**TIMBER RIDGE
PLANNED DEVELOPMENT NO. 60
BASE ZONING DISTRICT: SF-A SINGLE FAMILY
ATTACHED
ORDINANCE NO. 22-03-17-10
(ADOPTED 3-17-2022)**

- PDA22-0002: MINOR PD AMENDMENT – SITE DESIGN CHANGES (APPROVED BY STAFF 4-20-2022)**

Minor PD, Planned Development Amendment Application*

APPLICANT MODIFICATION/AMENDMENT REQUEST: PD to be Amended: PD-60 Timber Ridge SF Attached Townhouse

EXHIBIT "D-2"

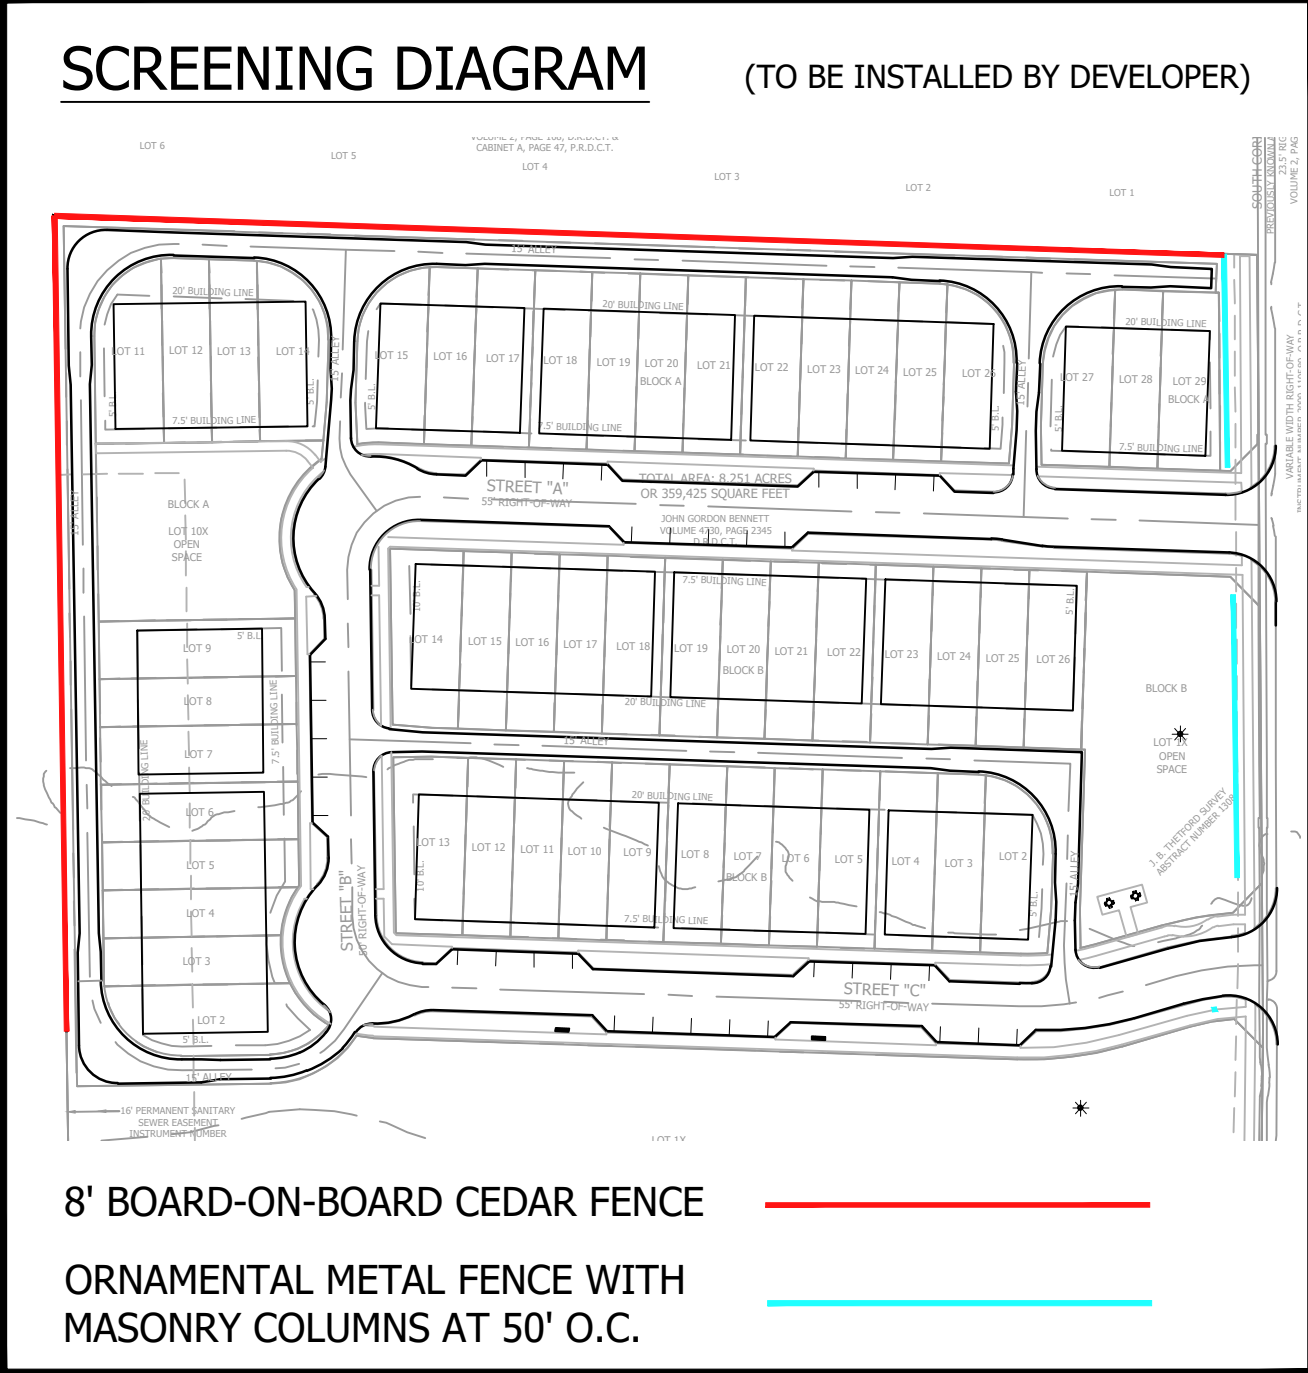
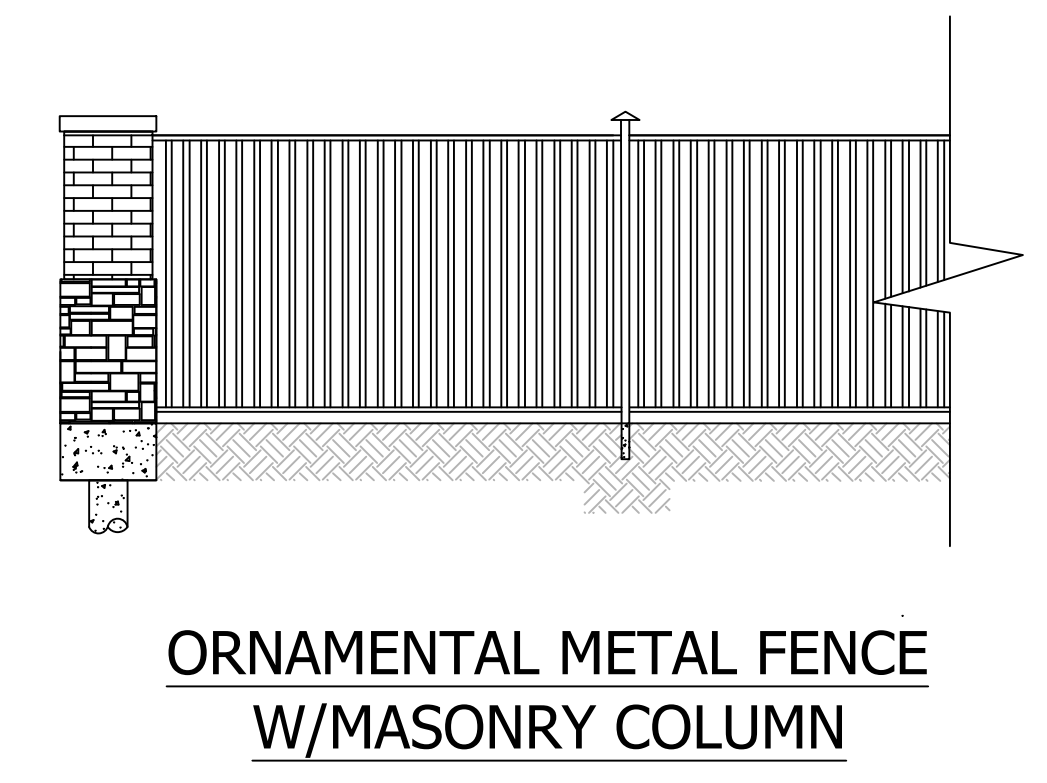
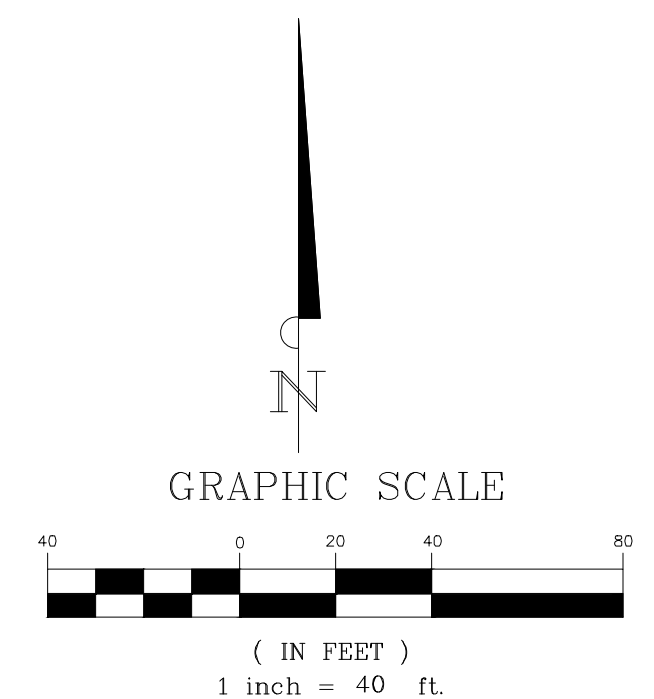
Request: To amend PD-60 to reflect the concepts presented in the attached Exhibit "D-2" Landscape and Screening Concept Plan to adjust the site design to address stormwater management on site and floodplain challenges.

Design changes include:

- (1) loss of two lots along Street A, (2) addition of one lot along Street B, (3) the enlargement of the "common open space gathering area" on east side of site between Streets A and C., (4) A wet retention pond with a "fountain" and a perimeter lawn area being added to the common open gathering open space (picnic/grill area) including short hard edge along western side of pond, (5) stairs are being provided from Street A (north) down into the open space/pond area and will be constructed of concrete with stone veneer on the exposed eastern face, (6) a decomposed granite path is being provided from Street C (south) into the "gathering space from the sidewalk, (7) a Protected Tree located within the area of the "gathering space" is being removed due to the location of the pond, however, another Protected Tree is being preserved at the south side of the intersection of Street C/Corinth Parkway.

Additionally, PD-60 reserves the right to develop the site under the original PD Concept Plan should future findings related to the Flood Study permit the original design.

Staff Comments/Conditions:

The amended design meets the intent and requirements of PD-60.
